# Dixie-Narco®

## Service Bulletin # \_\_\_\_\_

MODELS: DN174-6  
DN204-6  
DN246-6

SUBJECT: Modified Formed Shim - Left and Right

BOTTOM END VIEW  
FIG. 1

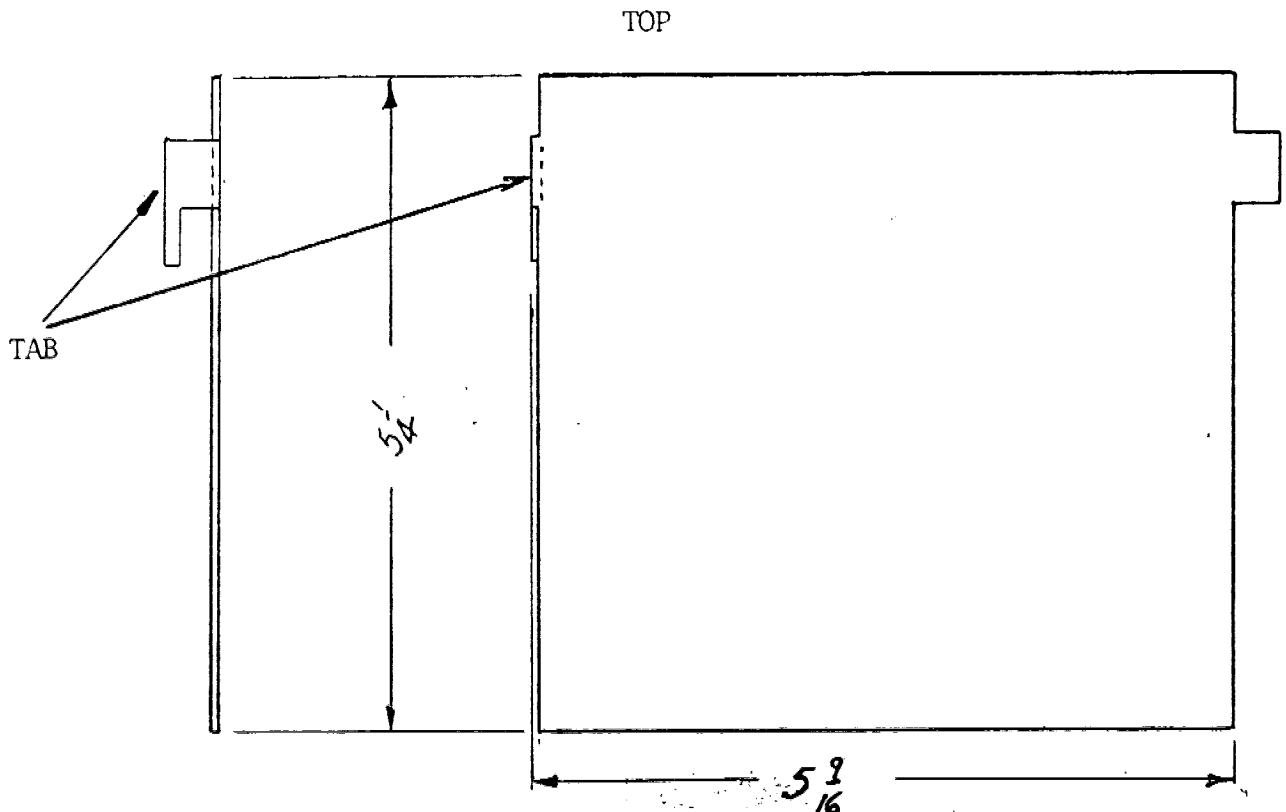
REASON: 1. To provide a "thinner" (16ga) formed shim that would retain flat shims.  
2. To shim these "old" Models so as to satisfactorily vend the 10 oz. NR "B" Bottle.

ORDER AS: B2500.06-1 Right Standard Flat Square Shim will  
B2500.06-2 Left fit back of these shims

INSTALLATION: 1. Bend "Tab" approximately 30° (degrees) clockwise. On Right Hand Shim Only. (This prevents butting of "tabs" between column walls.)  
2. Install 1 Modified Shim and 2 Flat Shims on Left and Right Side of Each Column.
